ISSUE	DATE	DRAWN	CHECKED	DESCRIPTION
<b>DRAWING TITLE</b>				GA PLAN PROPOSED GROUND FLOOR LEVEL PLAN
<b>DRAWING NO.</b>				CTH-PUR-MP-G0-DR-A-92001
<b>REVISION</b>				P02
<b>SIZE &amp; SCALE</b>				A1L 1:200 @A1
<b>DRAWING STATUS</b>				Issued for Planning

<b>CLIENT</b>	Lendlease	
<b>PROJECT</b>	Camden Town Hall	
<b>JOB NUMBER</b>	238664

**I 92001** **PROPOSED GROUND FLOOR LEVEL PLAN**  
1:200 @ A1

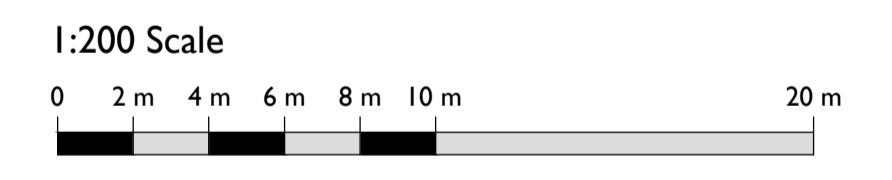
REVISION: Steps adjusted to provide 1800mm clear space between steps and tree pit

REVISION: Bollards removed from scheme to ensure 1800mm clear passing to pavement as governed by Camden Highways guidance

REVISION: Steps adjusted to suit existing levels

REVISION: Adjustments to SME lobby to incorporate Bin Store at ground floor. Area of glazed screen to basement reduced

REVISION - 2no. new columns to support roof structure of 1940's extension

REVISION - 2no. new columns to support roof structure of 1940's extension

REVISION - New aluminium profile glazed entrance lobby to replace existing and maintain thermal comfort. External steps demolished and rebuilt to match existing following condition survey
